**Class 1 Permit Modification Request  
Requiring Prior Approval for  
Administrative Changes at Technical  
Area 54, Area G, Pads 10 and 11, of  
the Los Alamos National Laboratory  
Hazardous Waste Facility Permit,  
EPA ID No. NM0890010515**

Appendix A	Redline Pages of Hazardous Waste Facility Permit, Attachments A, G.11, G.12, and J
Appendix B	Replacement Figures for Hazardous Waste Facility Permit, Attachment G.11, Figure G.11-1, Attachment G.12, Figure G.12-1 and Attachment N, Figures 27, 31 and 36
Appendix C	Microsoft Word Files of Revised Hazardous Waste Facility Permit, Attachments A, G.11, G.12, and J (on CD included with this document)

## **1.0 INTRODUCTION**

**Figure G.11-1: Technical Area 54, Area G, Pad 10 Outdoor Container Storage Unit Sampling Grid and Additional Sampling Locations**

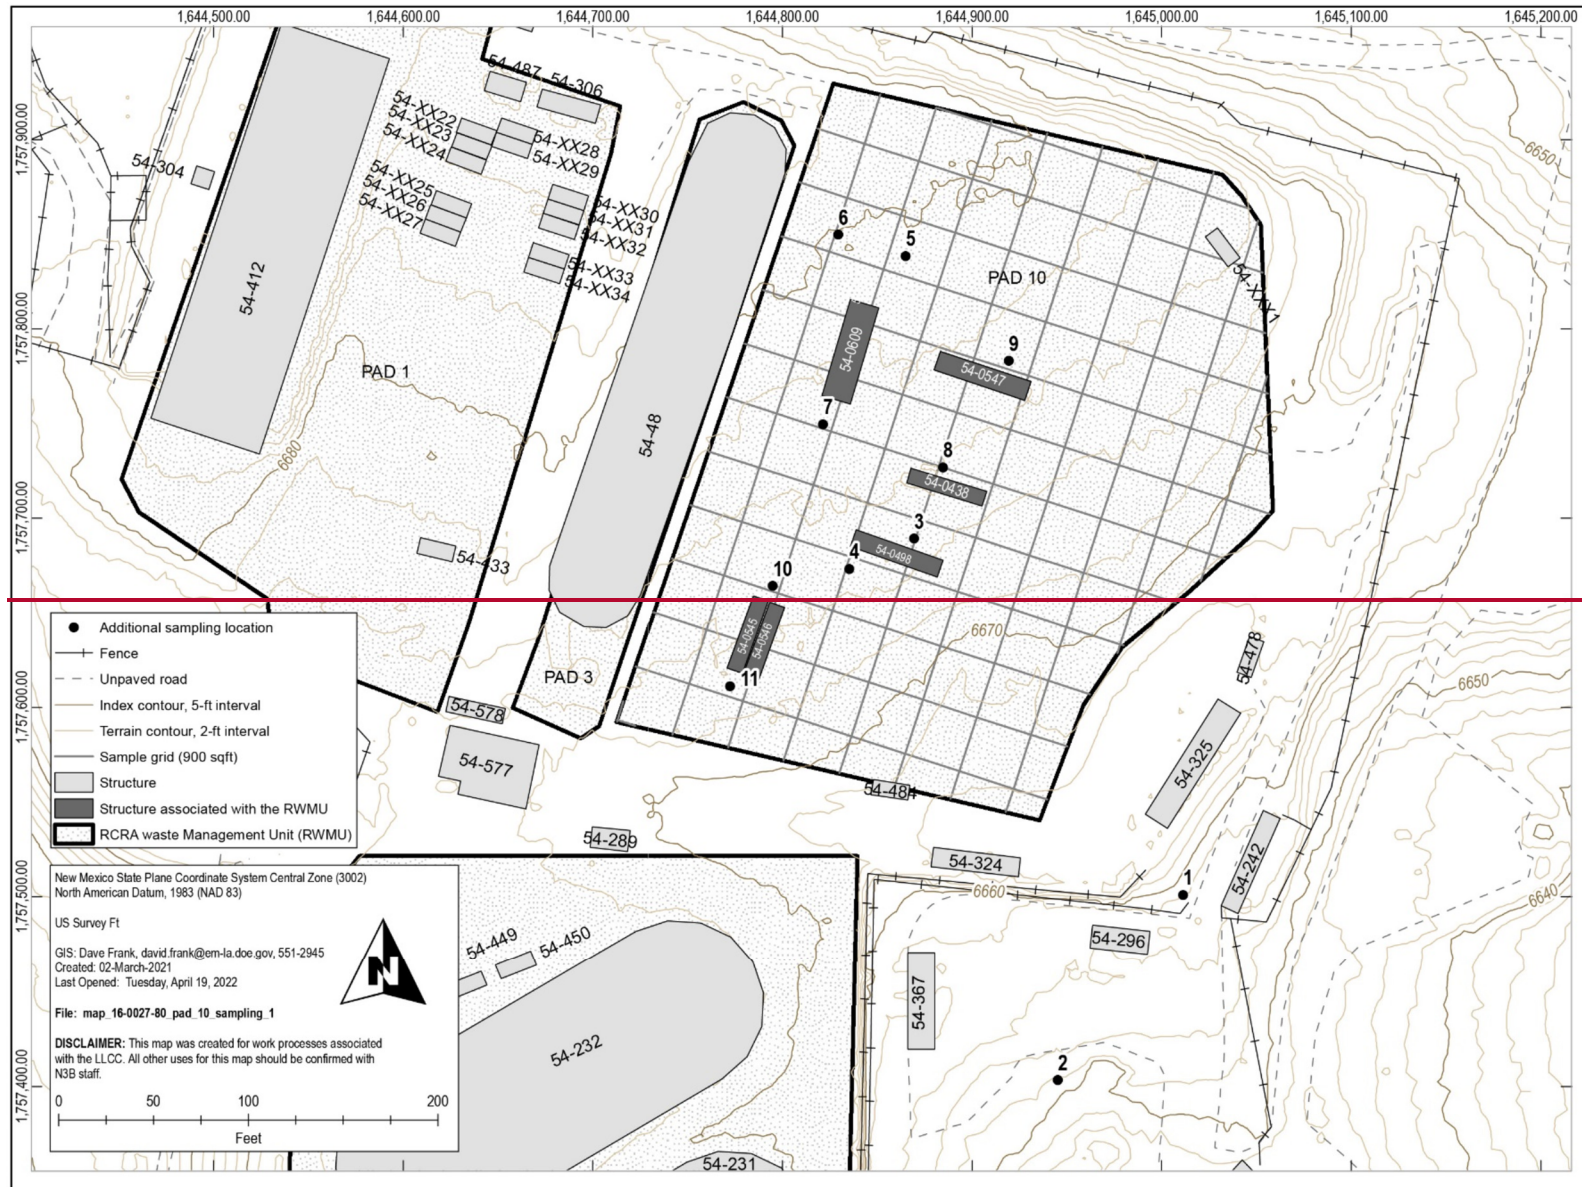
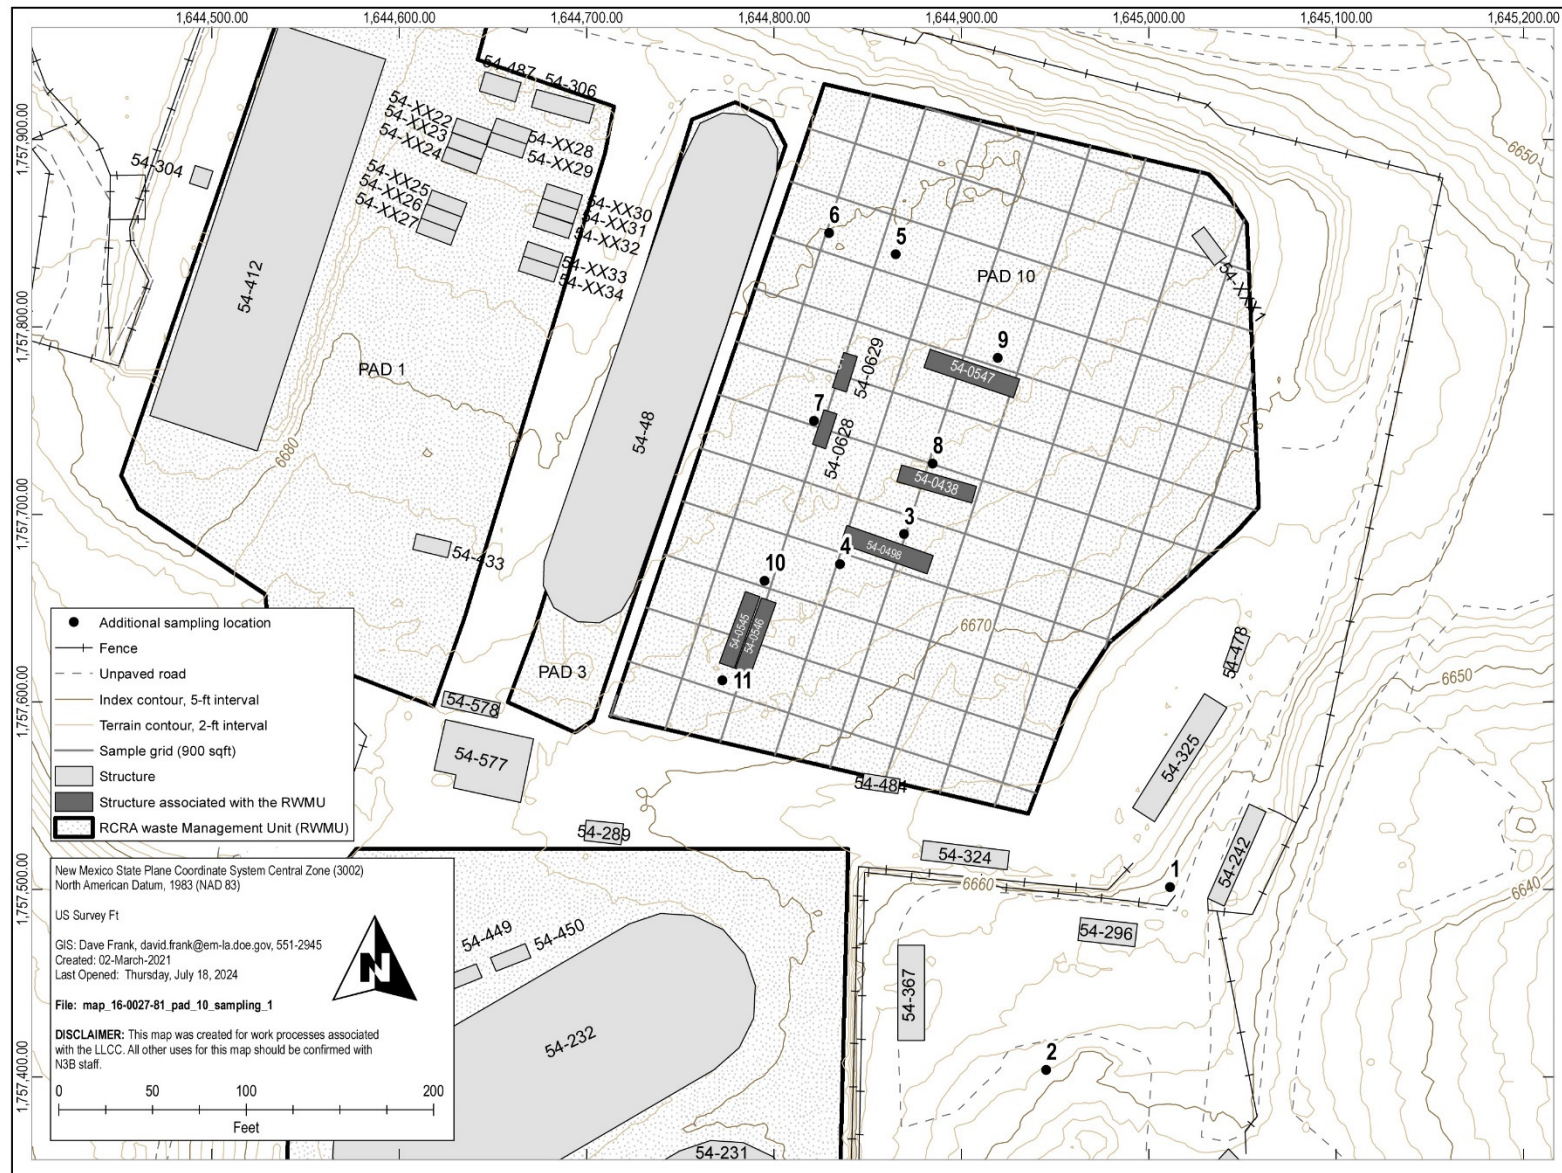
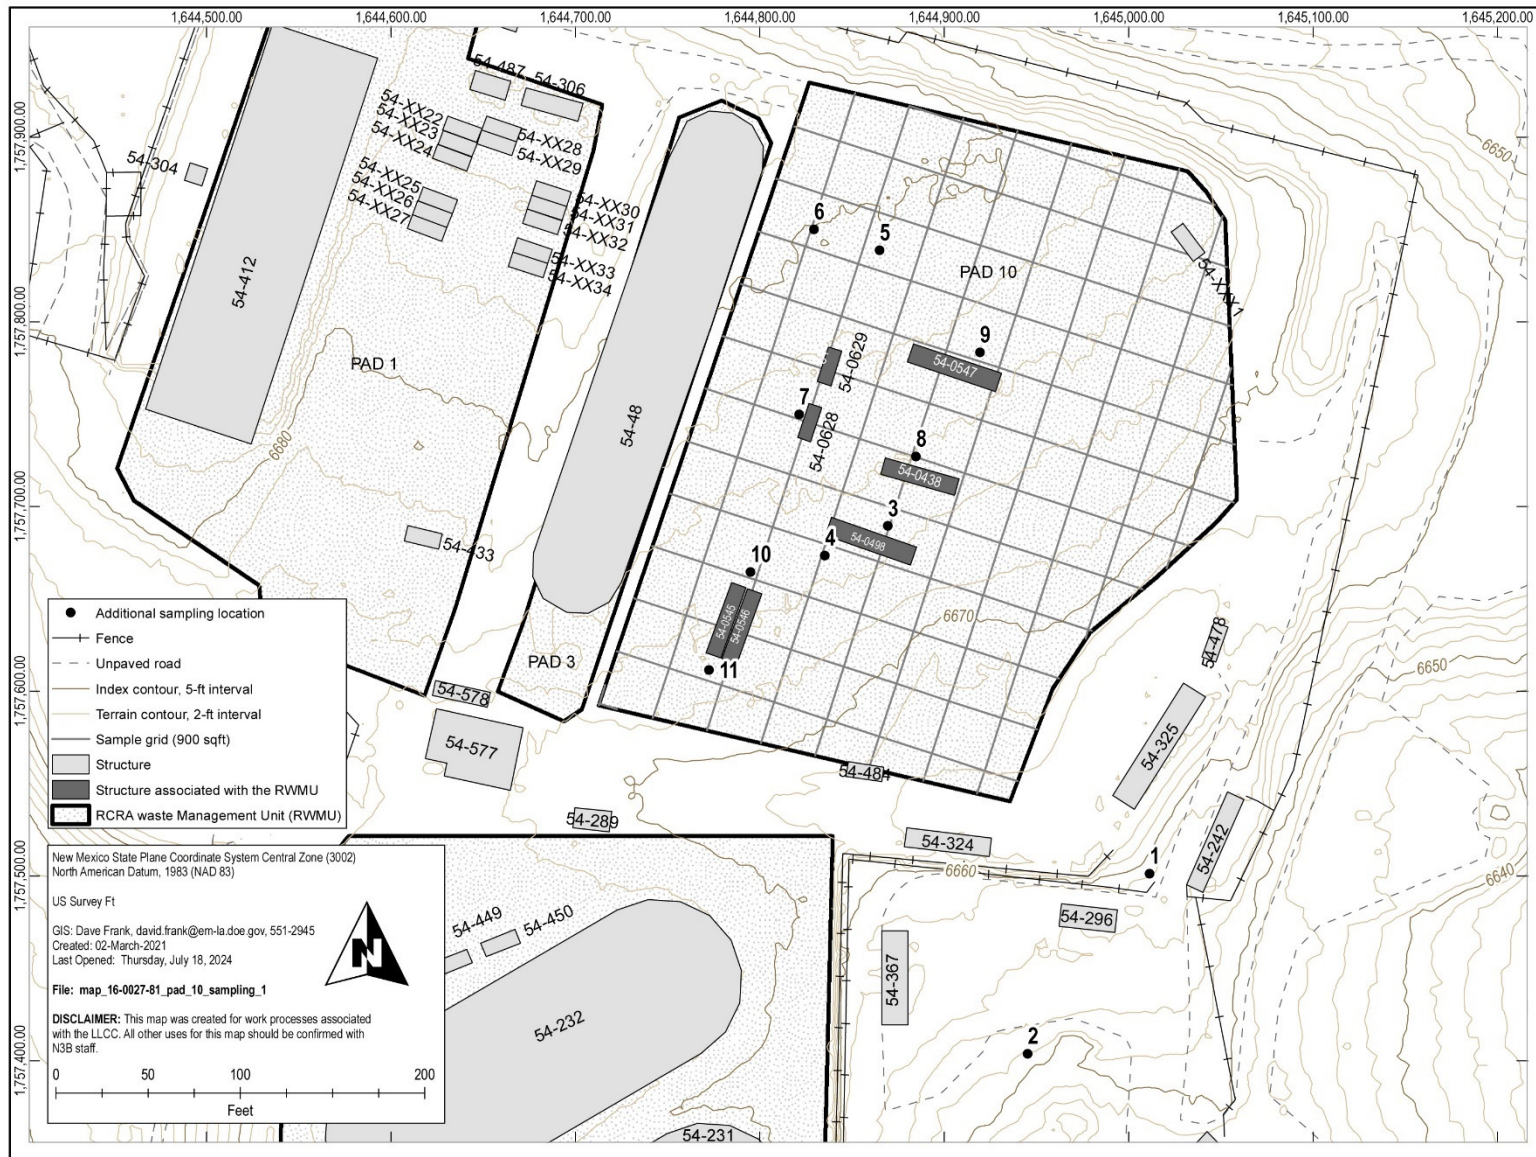
- Revised Figures (Attachment N, Figures 27, 31, and 36 and Figures G.11-1 and G.12-1). Figure 27 was revised to remove the UDASS (Pad 11) and the RTR unit (54-0609)(Pad 10) and add the two conex boxes (54-0628 and 54-0629) at Pad 10. Figure 31 and G.11.1 were revised to remove the RTR unit (54-0609) and add the two conex boxes (54-0628 and 54-0629). Figure 36 and G.12-1 were revised to remove the UDASS at Pad 11.
